SUNDRY NOTICES AND REPORTS ON WELLS
Do not use this form for proposals to drill or to re-enter an
abandoned well. Use Form 3160-3 (APD) for such proposals

1. Type of Well Oil Well Gas W	Well Other		8. Well Name and No. FEDERAL 27/6	
2. Name of Operator H L BROWN OF	PERATING, LLC		9. API Well No. 3004120937	
3a. Address 300 W. Louisana, Midland, TX 79701 3b. Phone No. (include area code) (432) 683-5216		10. Field and Pool or Explorate BLUITT-SILURO-DEVONIAN, NOR	ory Area TH/BLUITT-SILURO-DEVONIAN, NORTH

Federal 27 6 30-041-20937 H L Brown Operating, LLC August 6, 2025 Conditions of Approval

Federal 27 #6 complete.xls 6/22/2025 1:23 PM

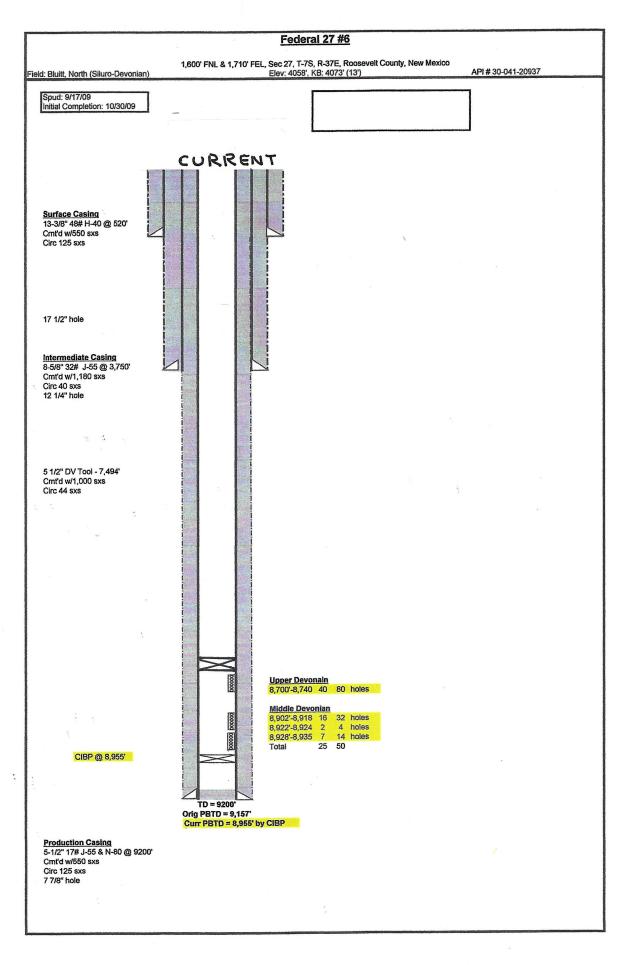
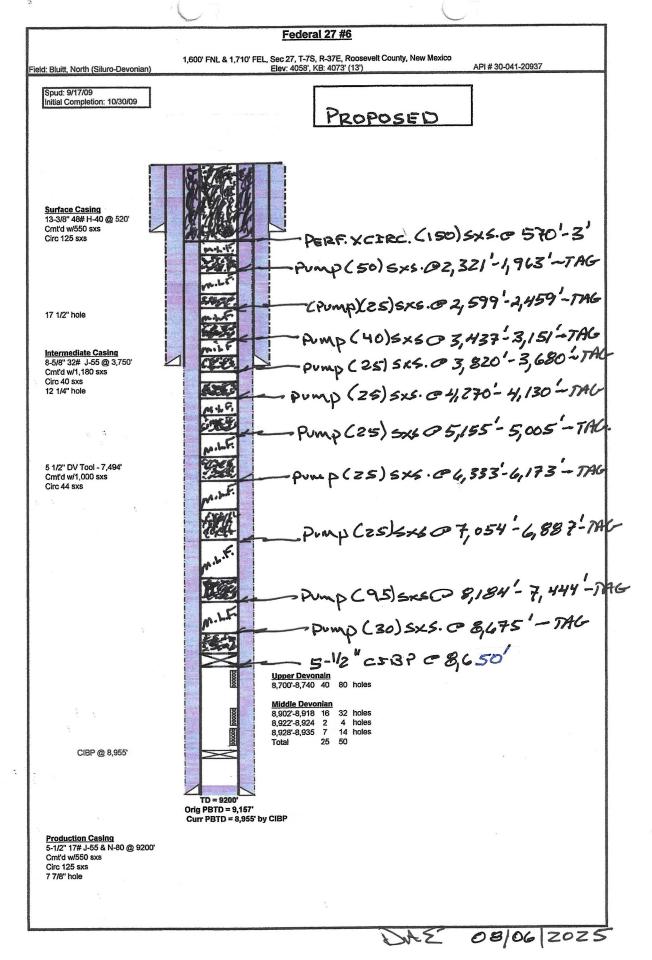
- 1. Operator shall place CIBP at 8,650'. Operator shall place 30 sx Class H cement on top of CIBP. <u>WOC and TAG.</u>
- 2. Operator shall place a balanced Class H plug from 8,184' to 7,444' to seal the top of Penn, top of the Wolfcamp, and the DV tool. WOC and TAG. Tag must be 50' above DV tool which is exactly 7,444'.

- 3. Operator shall place a balanced Class C plug from 7,054' to 6,887' to seal the top of the Abo Formation. <u>WOC.</u>
- 4. Operator shall place a balanced Class C plug from 6,333' to 6,173' to seal the top of the Bone Spring Formation. <u>WOC.</u>

- 5. Operator shall place a balanced Class C plug from 5,155' to 5,005' to seal the top of the Glorietta Formation. <u>WOC.</u>
- 6. Operator shall place a balanced Class C plug from 4,270' to 4,130' to seal the top of the San Andres Formation. WOC.

- 7. Operator shall place a balanced Class C plug from 3,820' to 3,680' to seal 8-5/8' casing shoe. <u>WOC.</u>
- 8. Operator shall place a balanced Class C plug from 3,437' to 3,151' to seal the top of the Queen and Grayburg Formations. WOC.

- 9. Operator shall place a balanced Class C plug from 2,599' to 2,459' to seal the top of the top of Yates and Base of Salt Formations. <u>WOC.</u>
- 10. Operator shall place a balanced Class C plug from 2,321' to 1,963' to seal the top of the top of Salt and Rustler Formations. <u>WOC.</u>

- 11. Operator shall perf at 570' and squeeze cement class C cement to surface to seal the 13-3/8" casing shoe.
- 12. Dry hole marker must be below ground.
- 13. Surface reclamation will need to be completed once the well bore has been plugged. Please contact <u>rflores@blm.gov</u> for additional information.
- 14. See attached for general plugging stipulations.
